## Planning and Transportation Committee

4. **SITE BOUNDED BY FENCHURCH STREET, MARK LANE, DUNSTER COURT  
AND MINCING LANE - LONDON, EC3M 3JY**  
Supplementary Document – Further Objection from Generali.

## DAYLIGHT & SUNLIGHT OVERSHADOWING ASSESSMENT

**50 Fenchurch Street and 120  
Fenchurch Street**

Figure 01: Planing Image of the Roof Scape

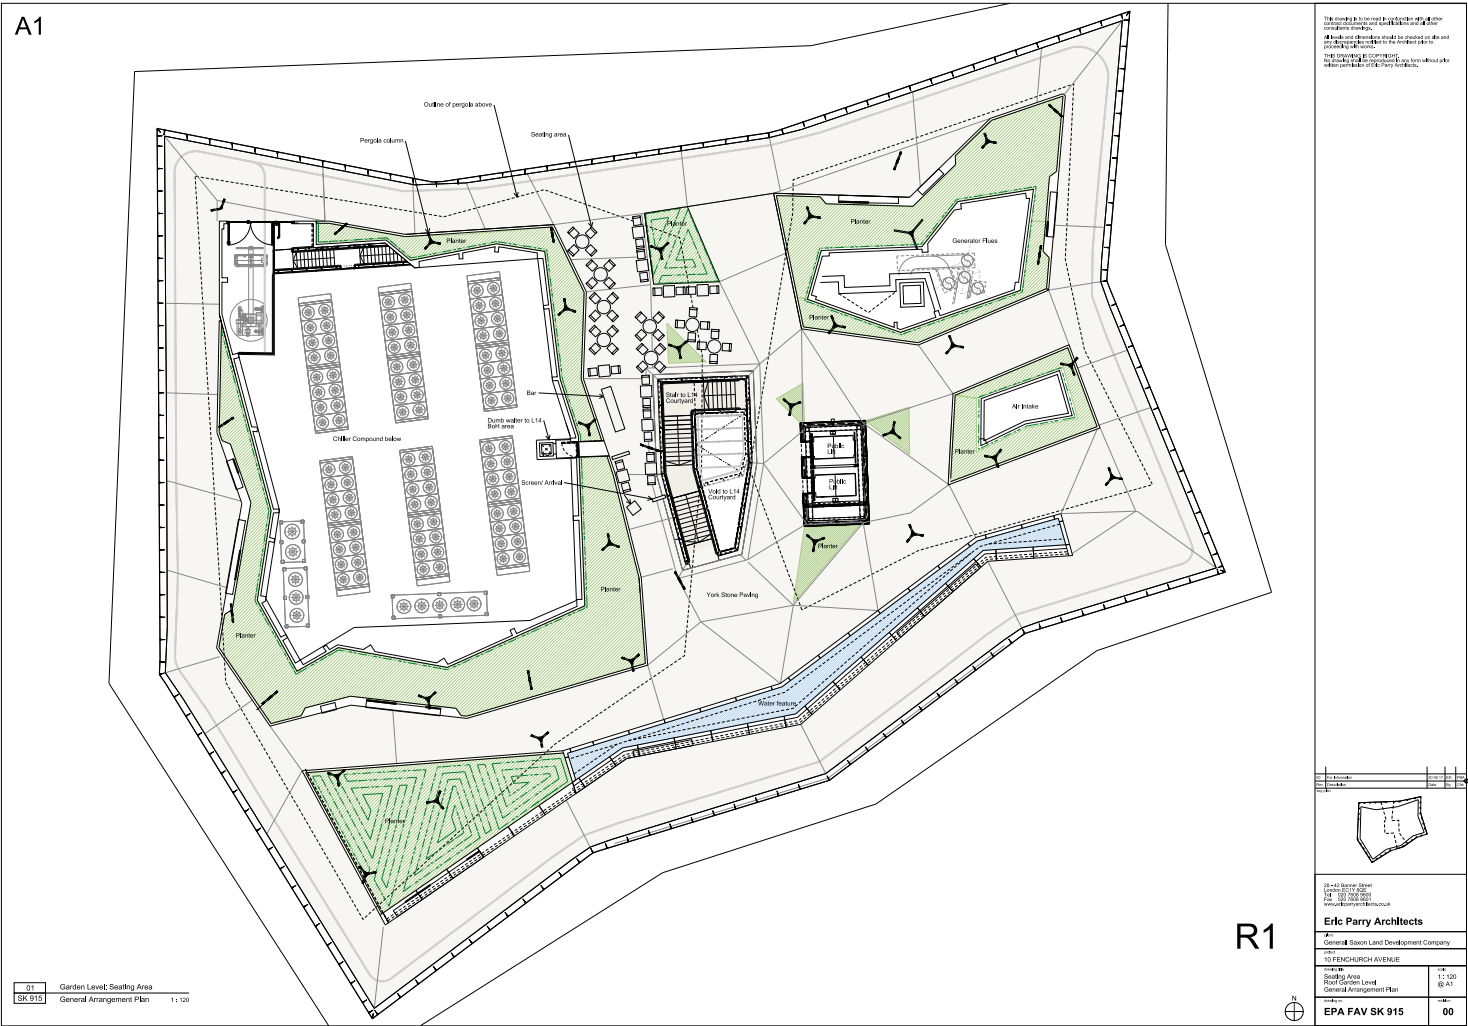
In response to paragraph 1.8 of the Point 2 letter, please note that GIA have used the layout design as per planning reference 18/00031/FULMAJ the specific reference for the drawing used is 18\_00031\_FULMAJ- Seating\_area\_roof\_garden\_level\_general\_ arrangement\_plan-395229. This drawing can be seen in Figure 01 of this note.
- 1.5

As illustrated in Figures 01-03 the latest layout design for the roof scape at 120 Fenchurch Street is correctly modelled in both GIA’s and Point 2’s analysis.
- 1.10

Point 2 are incorrect to state that GIA have used the wrong drawings in order to model the roofscape of 120 Fenchurch Street.

Figure 02: GIAs Overshadowing Assessment

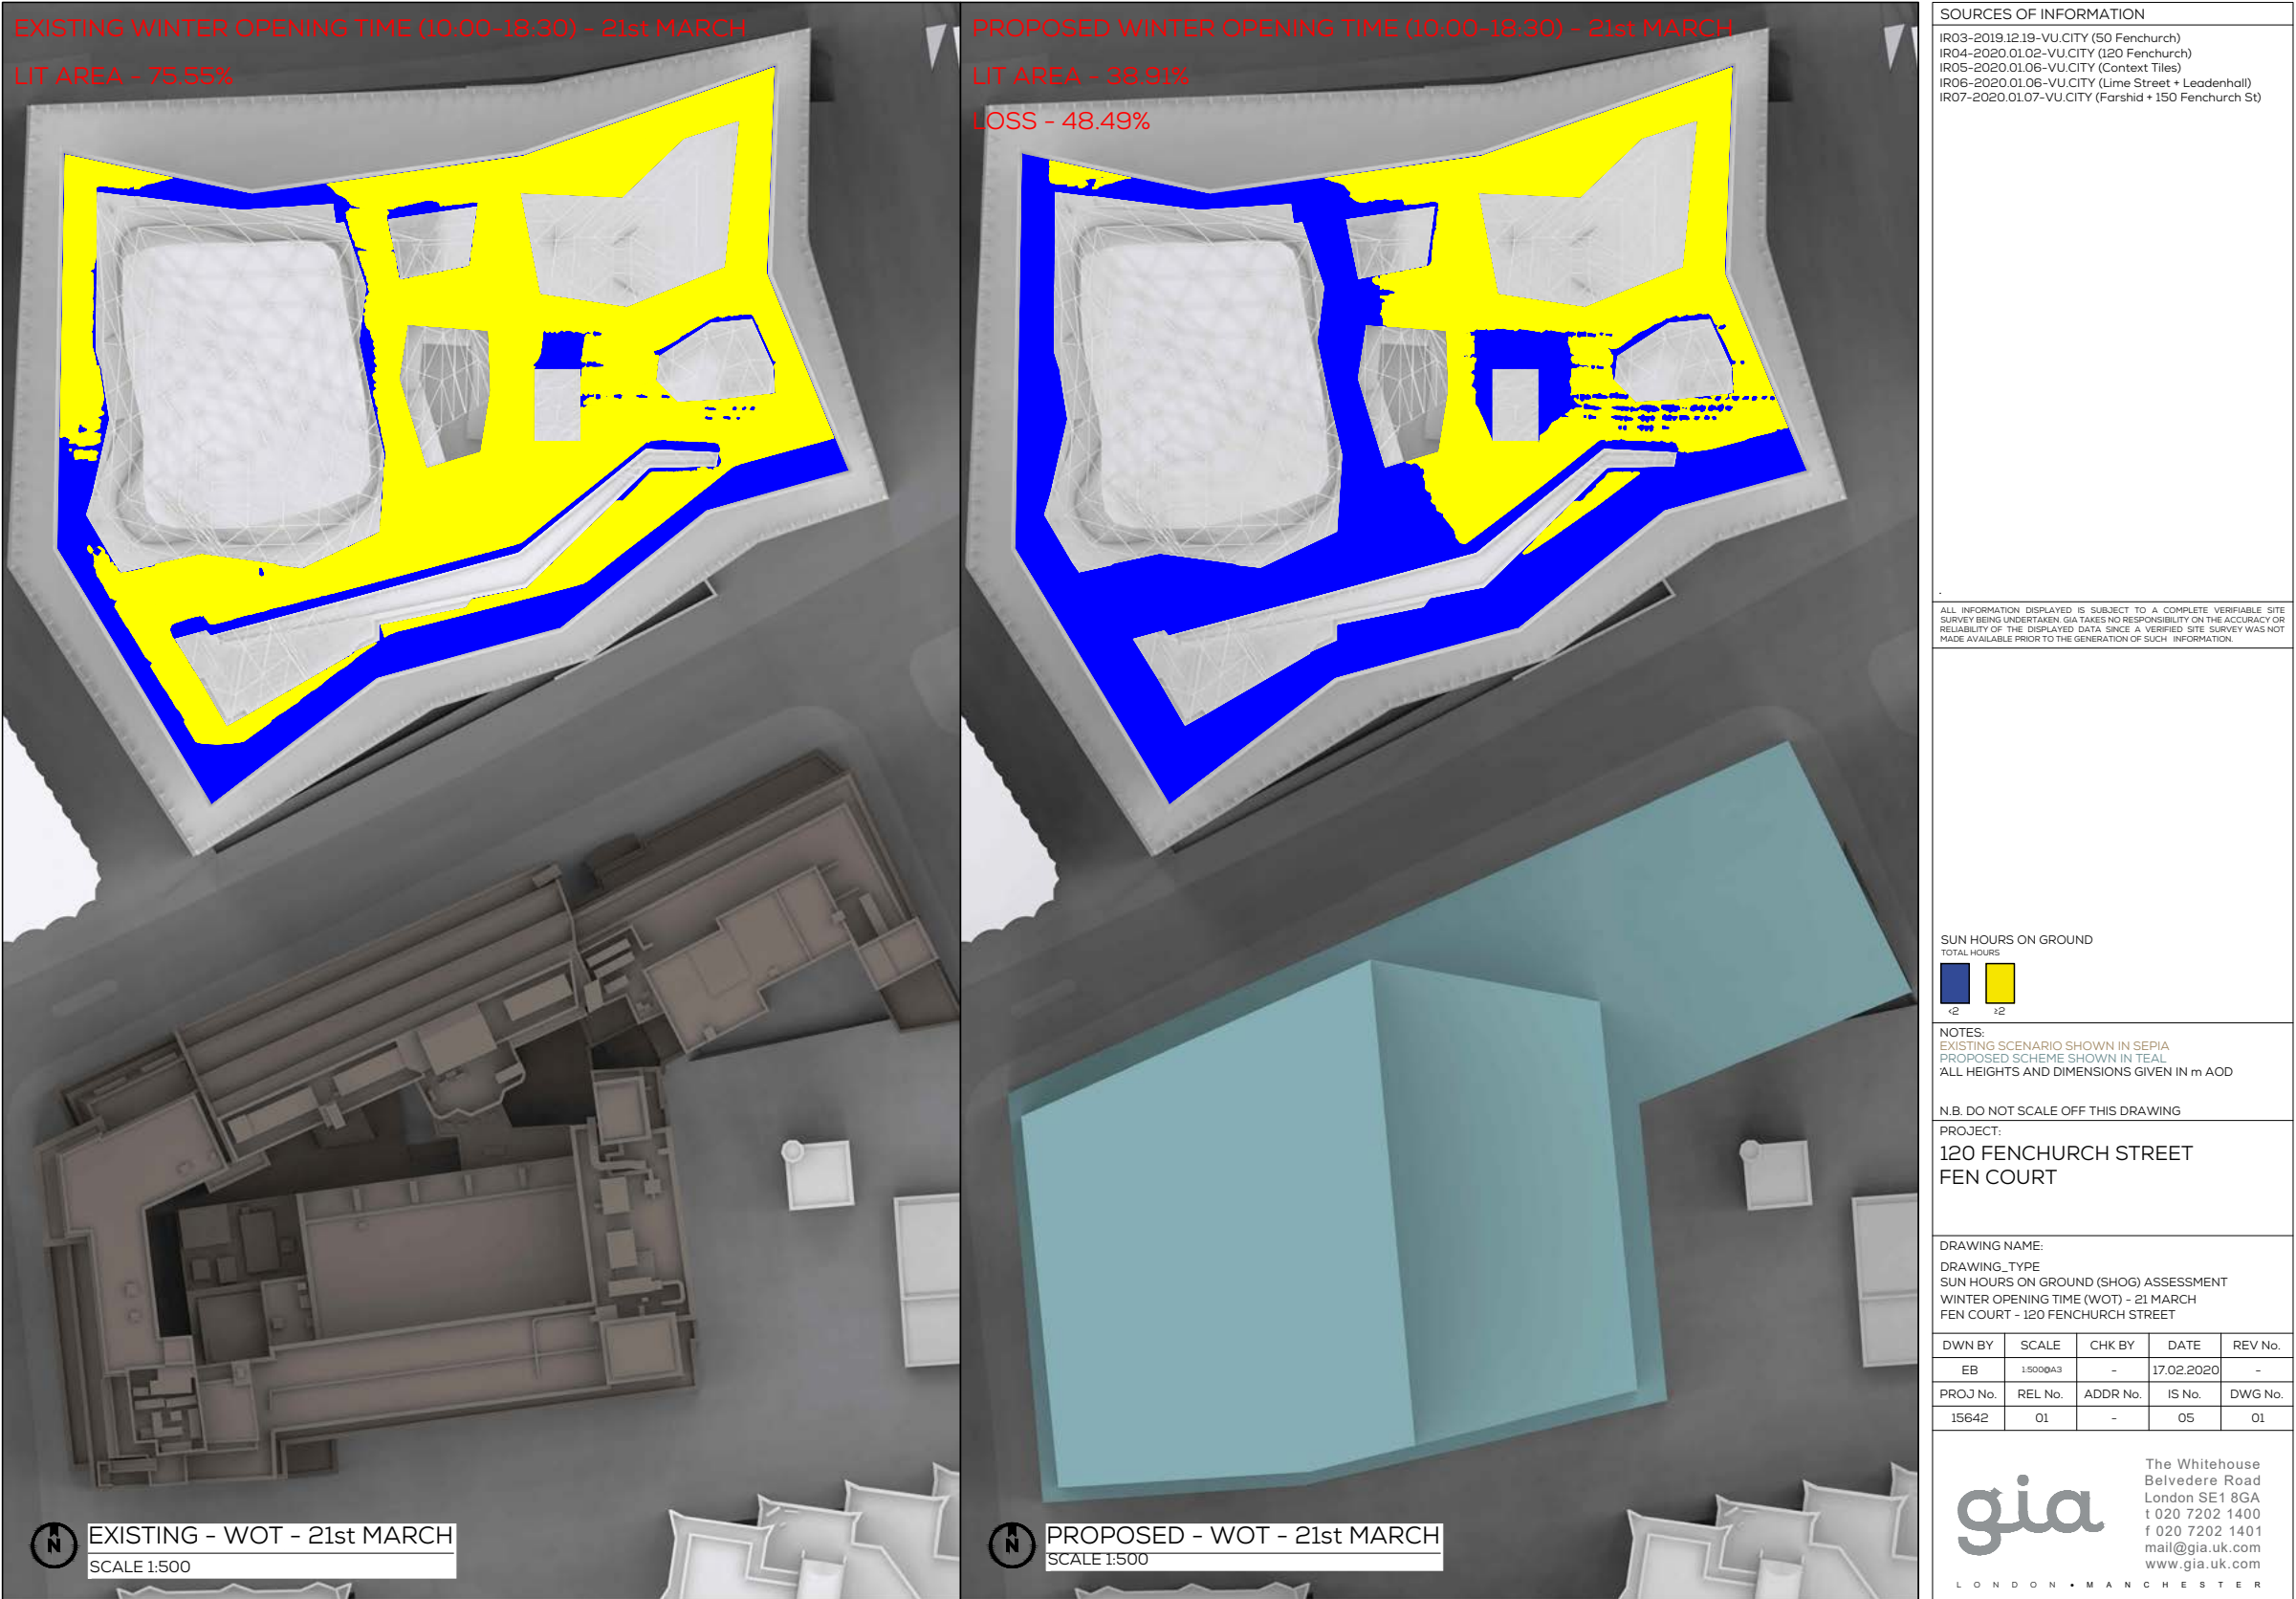
As is illustrated in GIAs drawing (see Figure 02) in consideration of the opening hours 38.91% of the space would receive 2 hours of sunlight on the 21st March (in the proposed cumulative scenario). This is on the basis of the latest layout design for the roof of 120 Fenchurch Street illustrated in Figure 01.
- 1.6

It should be noted that there are minor differences between GIA’s roofscape to the one that Point 2 have assessed. This is in relation to small triangular planting pits with pergola supports in them.
- 1.7

Two of these planting pits are in locations that, in accordance with GIA’s analysis, would receive direct sunlight in both situations. The smallest planting pits would go from being in sunlight, to in shadow, in accordance with GIA’s analysis.
- 1.8

The exclusion of these small planting triangles would not materially alter the conclusions as per GIA’s analysis.
- 1.9

Figure 03: Point 2s Overshadowing Assessment

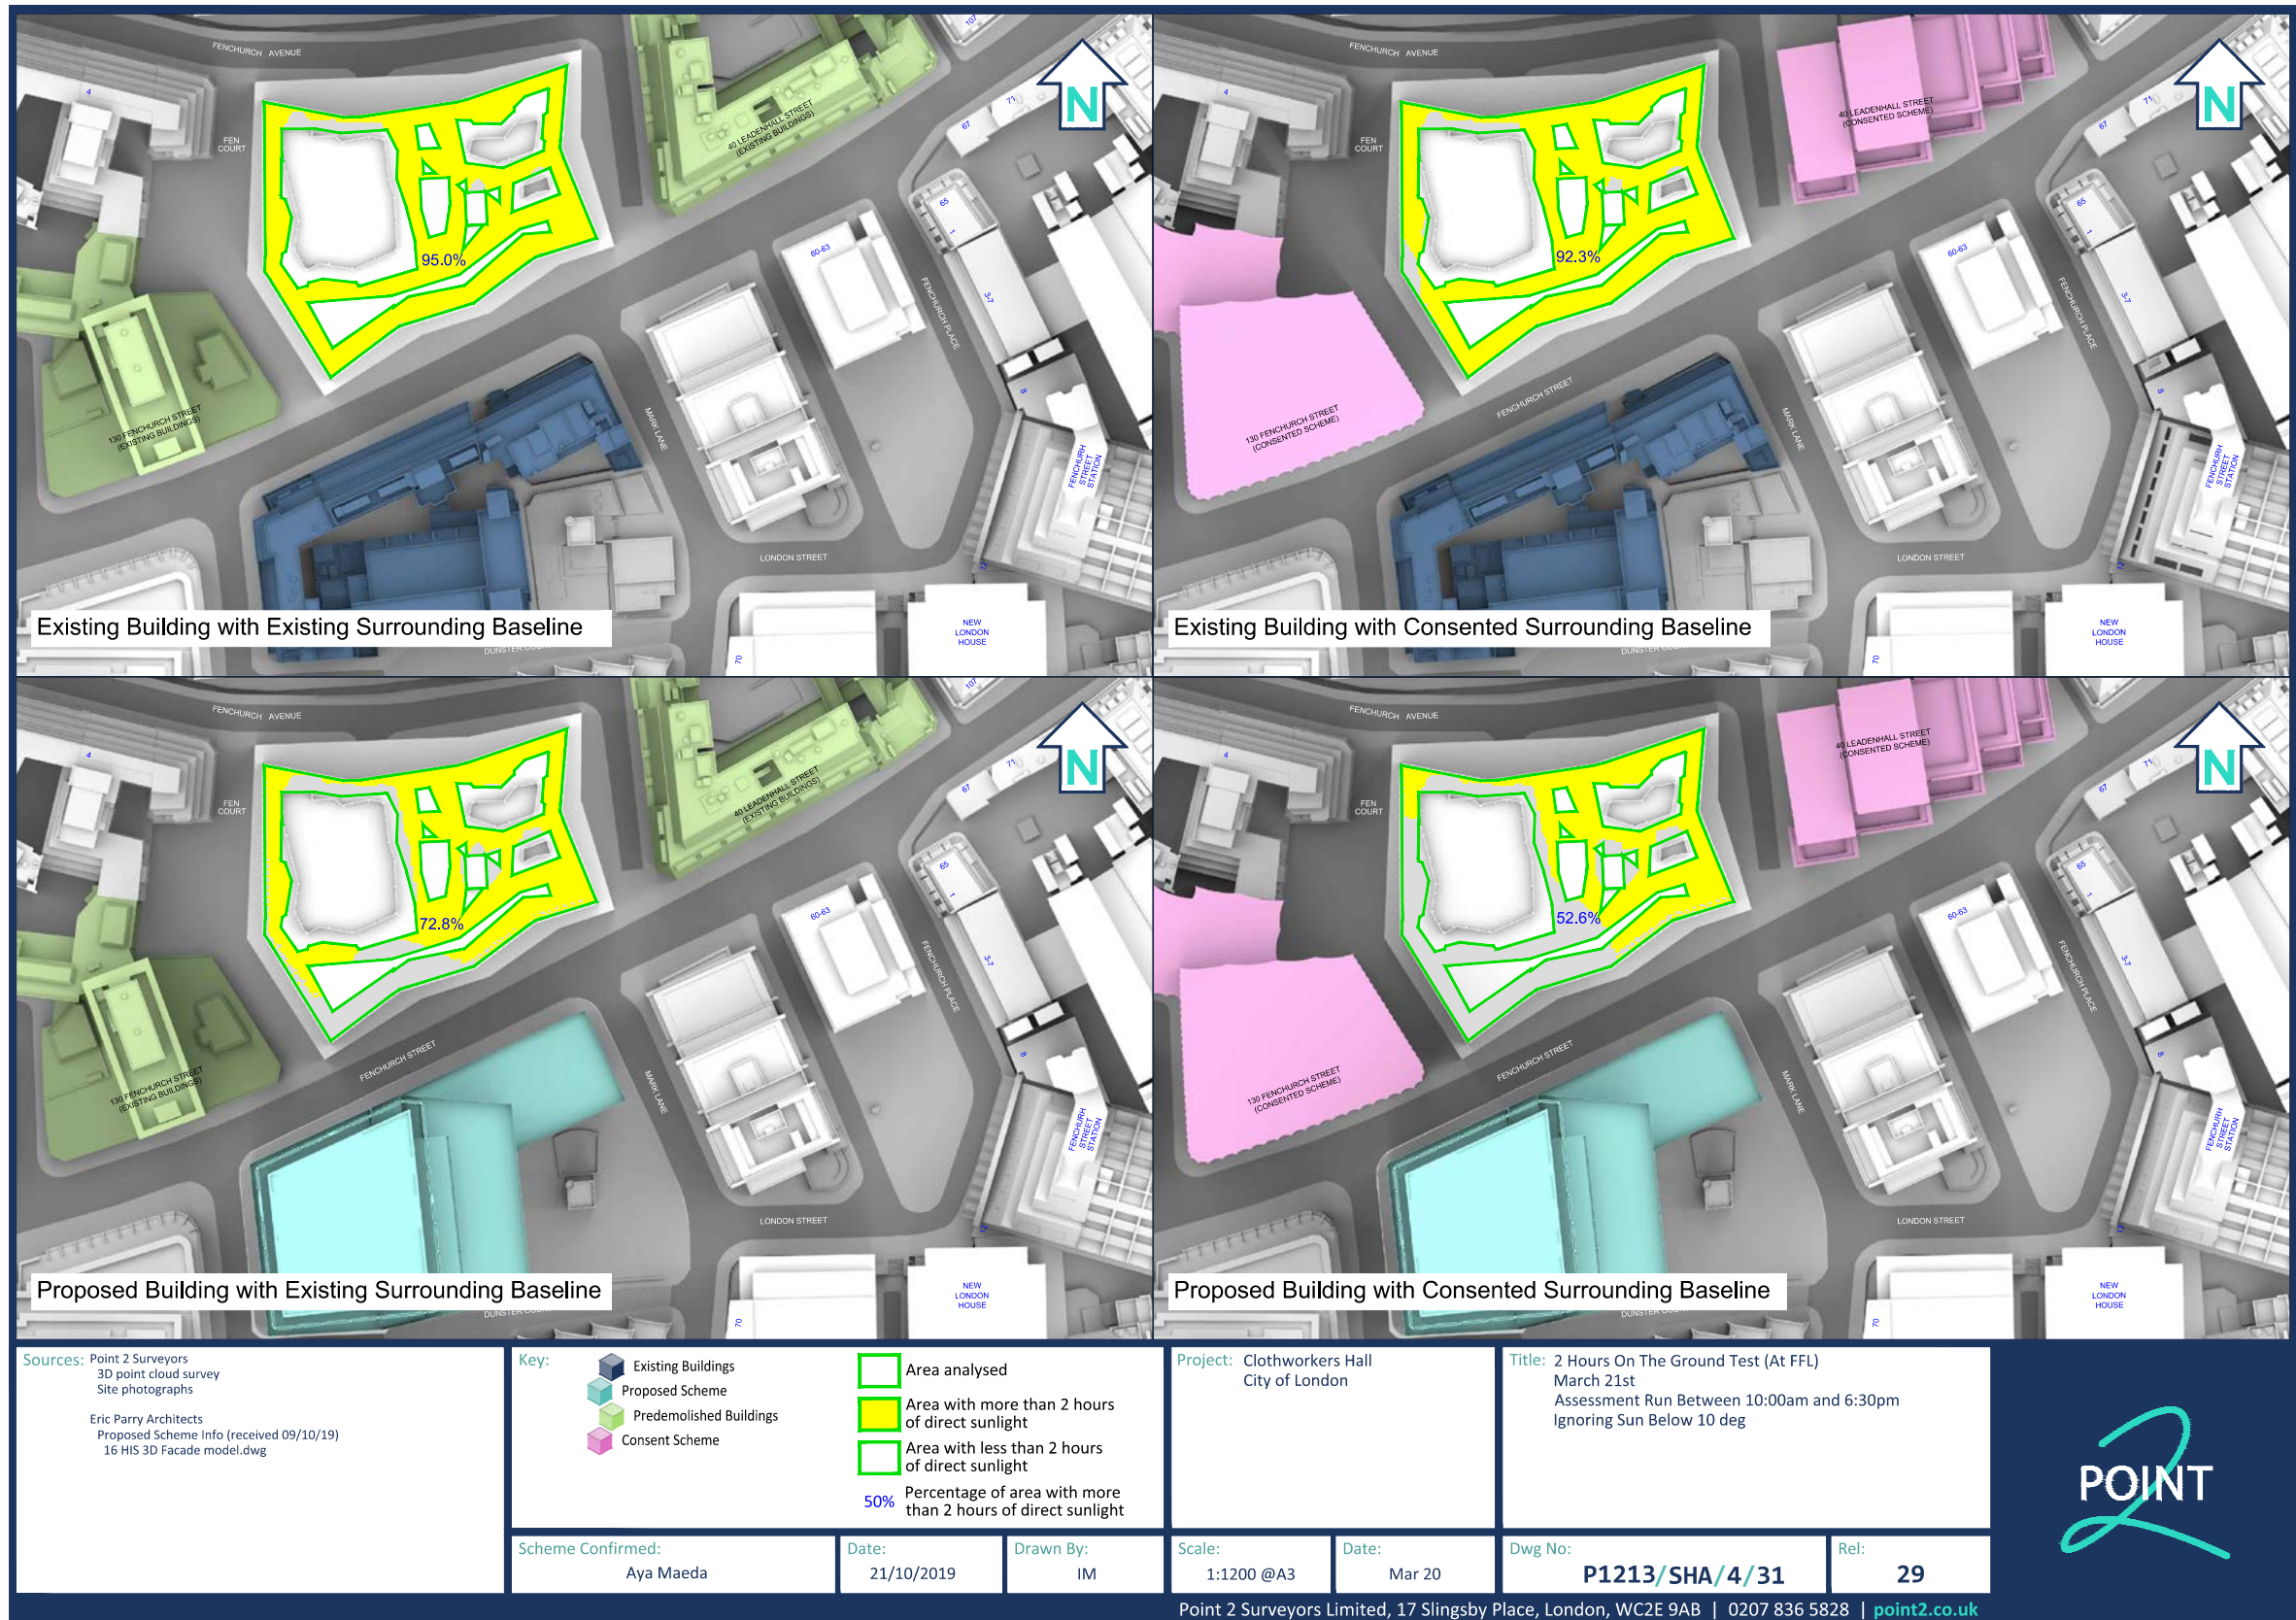
We therefore do not understand why the analysis undertaken by Point 2 (see Figure 03) is materially different to that undertaken by GIA.

As per the drawings included within Point 2’s EIA Chapter, the roofscape they considered for the purpose of their Sun on Ground analysis, is exactly the same as GIA’s.
